TO: All Bidders
FROM: City of Cambridge
DATE: February 4, 2013
RE: File No. 5998 – Expansion of SCADA/Telemetry System - Addendum No. 3

Addendum No. 3

CHD BY: _____ DATE: _____
 SUBJECT: DUAL PUMP CONTROL SCHEMATIC
 JOB NO.: _____ SHEET NO. _____ OF _____
 DWG. 1224 SH 1

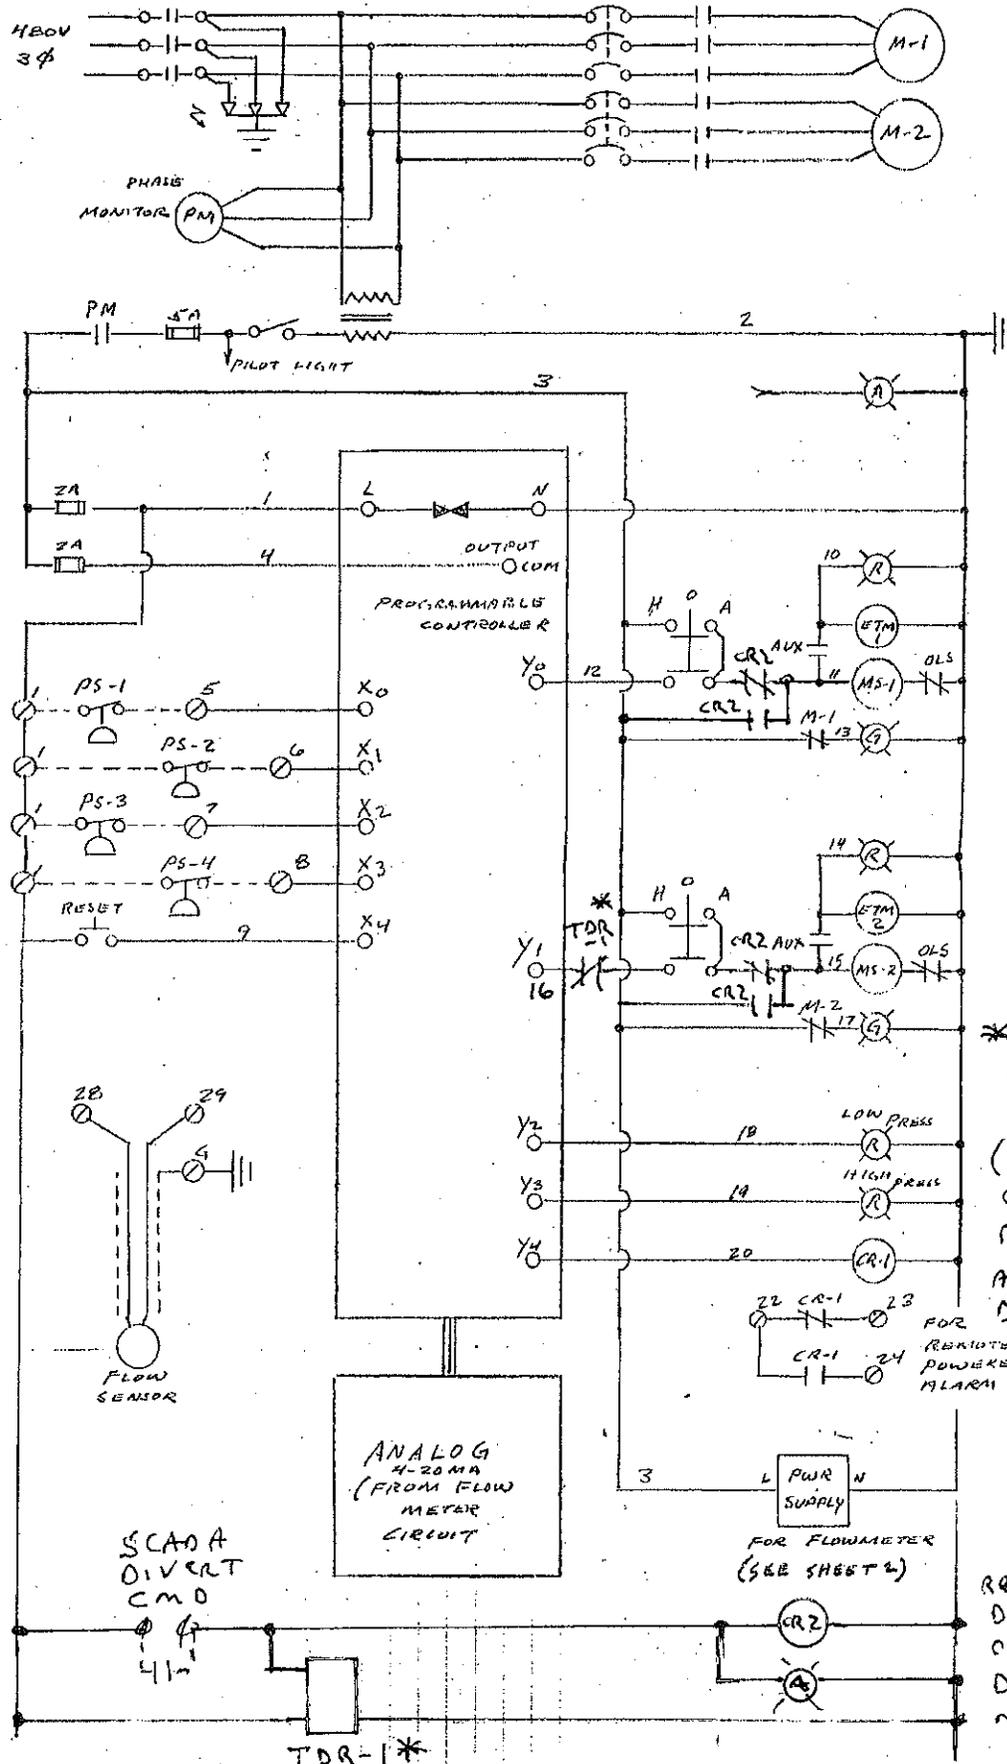
b. Modifications to existing Gustavo Preston Co. irrigation pump control panel. The Contractor shall modify the existing control panel as indicated by the clouded notations shown in Appendix 13300-A at the end of this section as follows:

- i. Modify the existing Gustavo Preston control panel to receive a dry contact from the RTU that shall energize new 3PDT general purpose relay, CR-2, in response to a remote DPW command to enter pump station diversion mode (CR-2 relay energized in DIVERSION MODE. CR-2 relay de-energized in IRRIGATION MODE.) Add a new 120vac oiltight indicator light with amber lens as indicated on the drawing to illuminate when the panel is in DIVERSION MODE operation. Furnish an engraved nameplate with this designation on the plate to identify the light. Tie in two form-C contact sets from CR-2 into the two pump control circuits as shown on the drawing to run both pumps continuously when DIVERSION MODE is selected and to run under normal control panel function when DIVERSION MODE is not selected (i.e., normal IRRIGATION MODE is selected). Wire the 3rd form-C NO and NC contacts to the existing DIVERSION VALVE control handswitch adjacent to the Gustavo Preston panel to select the REMOTE switch controls to OPEN the valve in DIVERSION MODE and CLOSE the valve in IRRIGATION MODE.

- ii. Furnish and incorporate an OFF DELAY (DELAY ON BREAK) time delay relay and configure it to change state five minutes after the RTU releases the panel from DIVERSION MODE to return to IRRIGATION MODE. Tie an output of this relay into the control circuit of the second pump as shown to prevent the second pump from operating for five minutes after the panel returns to IRRIGATION MODE of operation, to reduce surge pressure potential on the irrigation system.

- iii. Furnish and incorporate two general purpose relays, CR-3 and CR-4, as shown to provide dry contacts for RTU monitoring of the RUN statuses of Pump 1 and Pump 2 respectively. Note: Existing ALARM status CR-1 is already wired across terminals 22 and 24 as shown.)

c. Wire the modified Gustavo Preston panel modifications shown on Appendix 13300-A to the RTU as follows:

- i. RTU output terminals 21-22 (DO-0) to SCADA DIVERT CMD to control CR-2.
- ii. RTU input terminals 1-2 (DI-0) to N.O. contacts of CR-3 to indicate Pump 1 RUN status.
- iii. RTU input terminals 5-6 (DI-2) to N.O. contacts of CR-4 to indicate Pump 2 RUN status.
- iv. RTU input terminals 3-4 (DI-1) to N.O. contacts of CR-1 to indicate Common Pump Alarm.
- v. RTU input terminals 43-44 (AI-0) to hydrostatic pressure level transmitter to monitor Little Fresh Pond elevation. Note: Furnish 24vdc loop power using RTU 24vdc power terminals 41-42.
